RE: Application for Permit to Drill: Utah 30-1090, Utah 30-1088, Utah 19-1181, Telonis 30-1063
Revised APD for Utah 30-1062
Sundries for: Utah 2-1264, Utah 26-1197, Utah 26-1198, USA 30-1061

ON-SITE PREDRILL EVALUATION
Division of Oil, Gas and Mining

DIVISION OF OIL, GAS AND MINING
APPLICATION FOR PERMIT TO DRILL
STATEMENT OF BASIS

OPERATOR: ConocoPhillips Company
WELL NAME & NUMBER: Telonis 30-1063
API NUMBER: 43-007-31159
LOCATION: 1/4,1/4 NWSE Sec:30 TWP:14 S RNG:9 E 2493 FSL 1949 FEL

APPROXIMATE LAYOUT OF RIG & EQUIPMENT

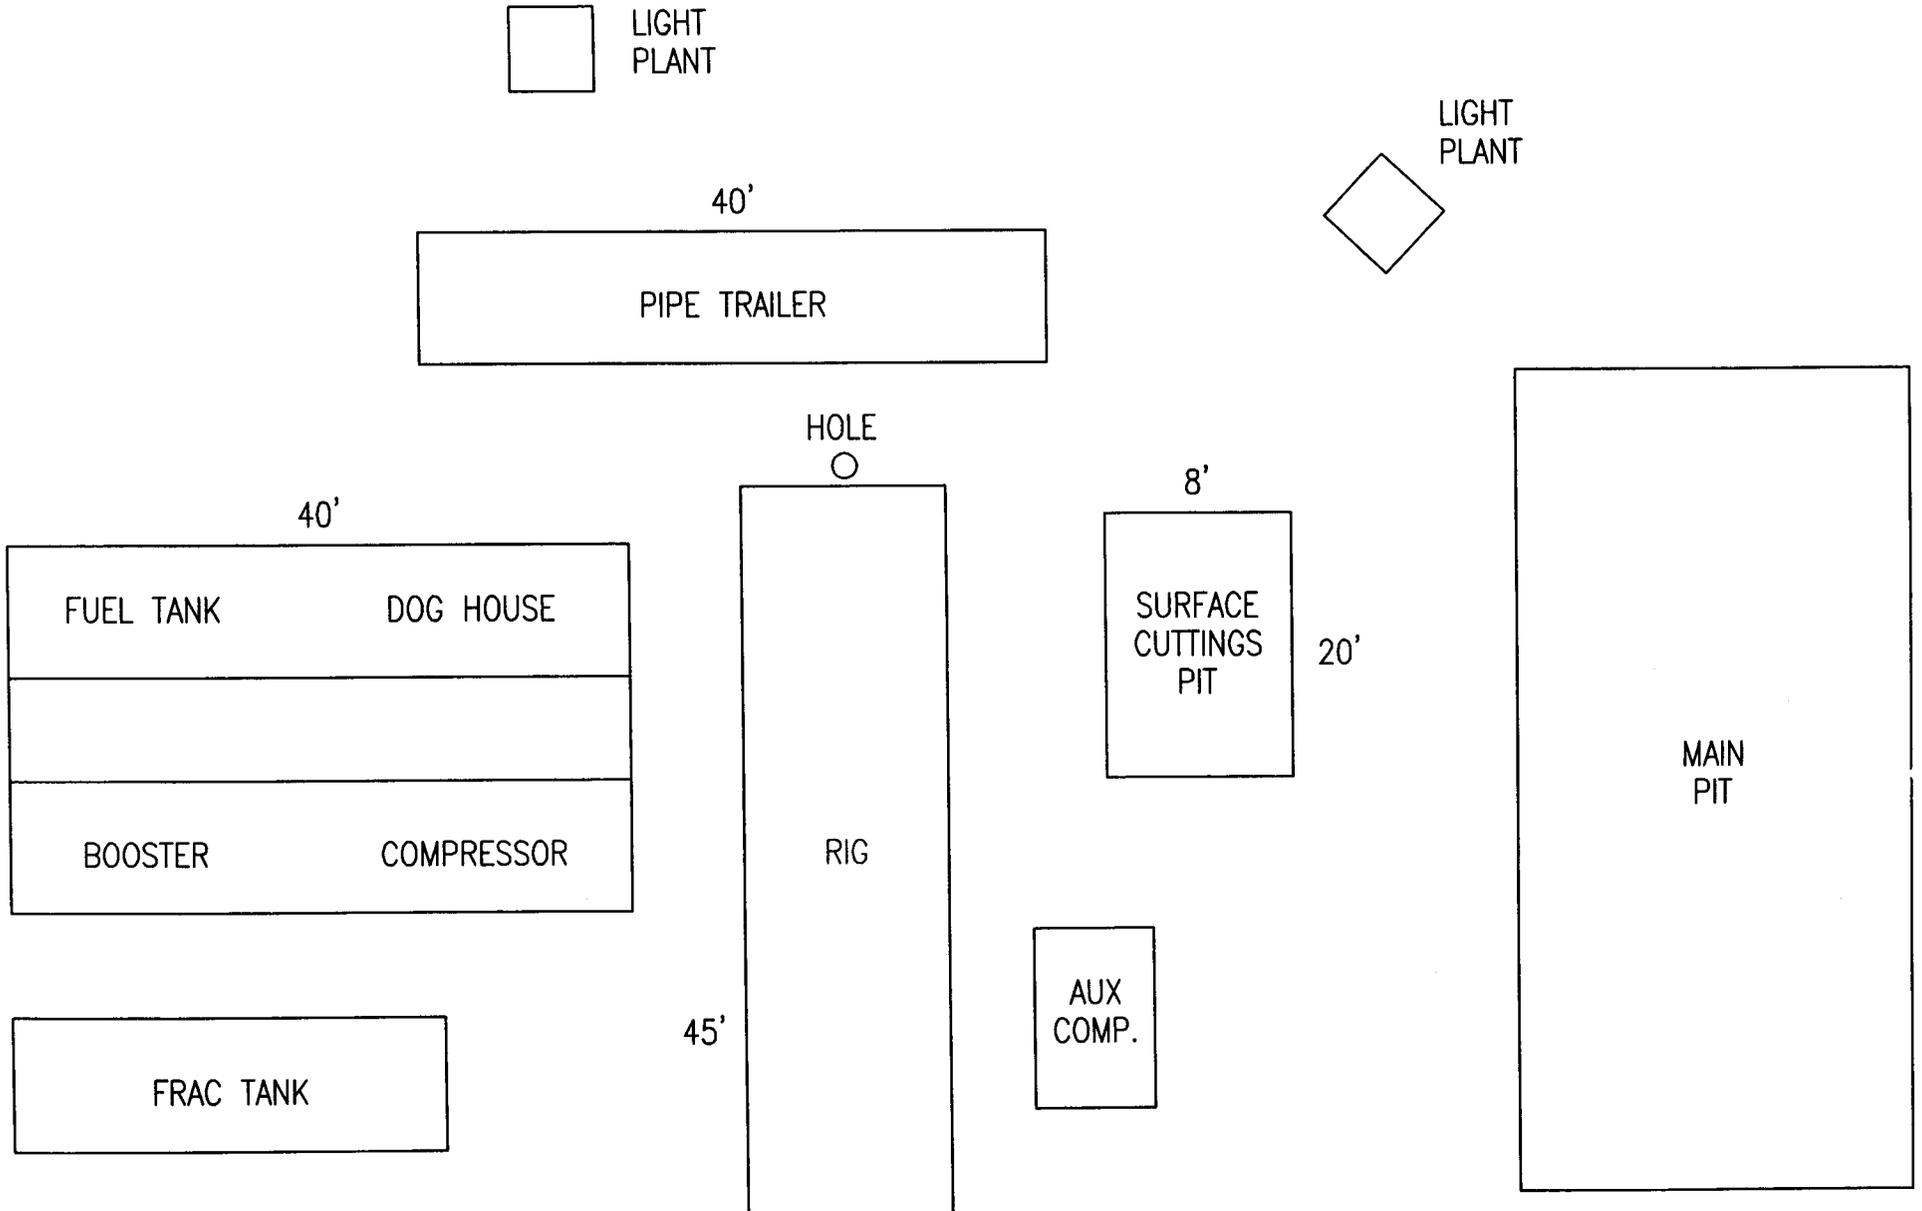
Rotate 90 degrees clockwise at NELCO's request to allow better access beyond this location.

Casing Schematic

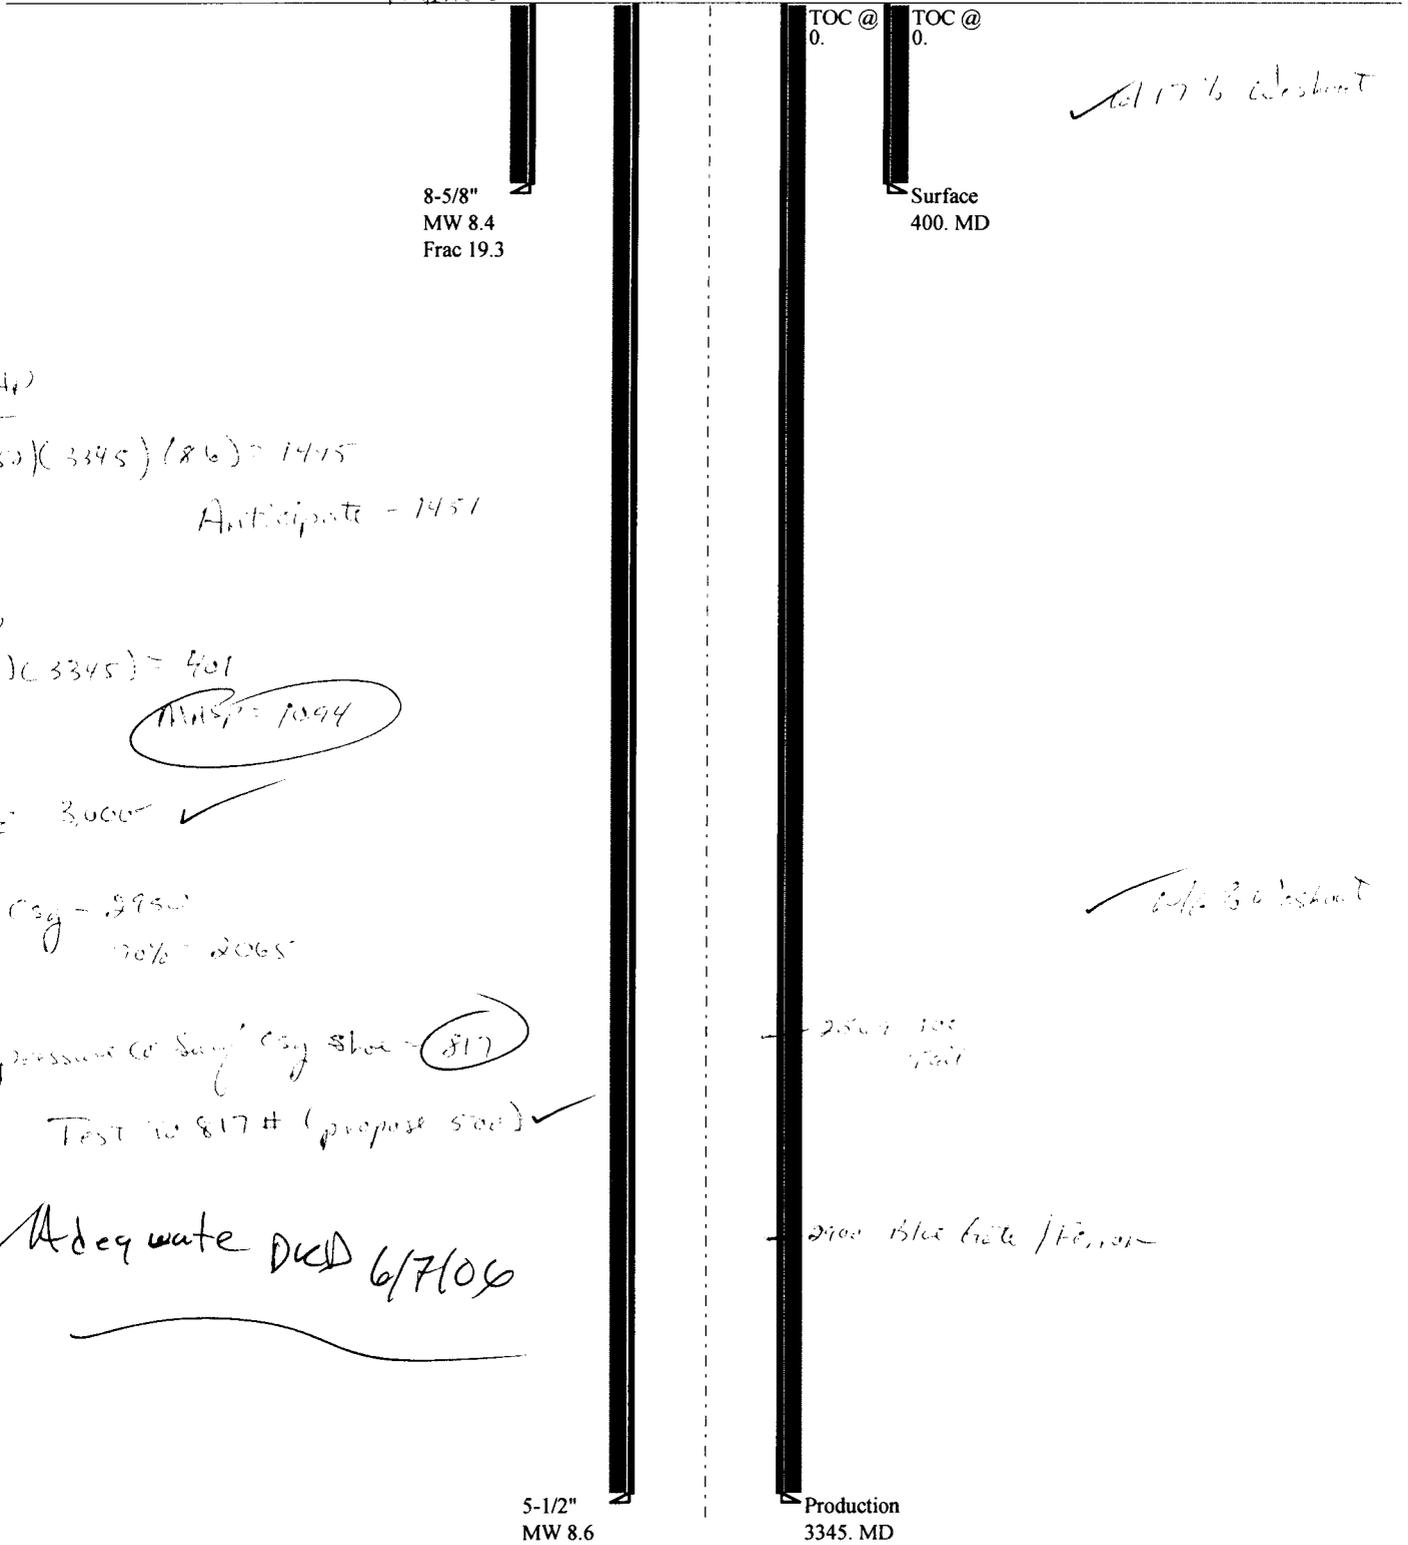
$$(2.05) \times (3345) \times (86) = 1445$$

Anticipate - 1451

$$(2.0) \times (3345) = 401$$

MWS = 1094

Bope 3000 ✓

Surf/Coj - 2950
70% - 2065

Max pressure @ Surf/Coj shoe - 817

Test to 817# (propose 500) ✓

✓ Adequate DUCD 6/7/06
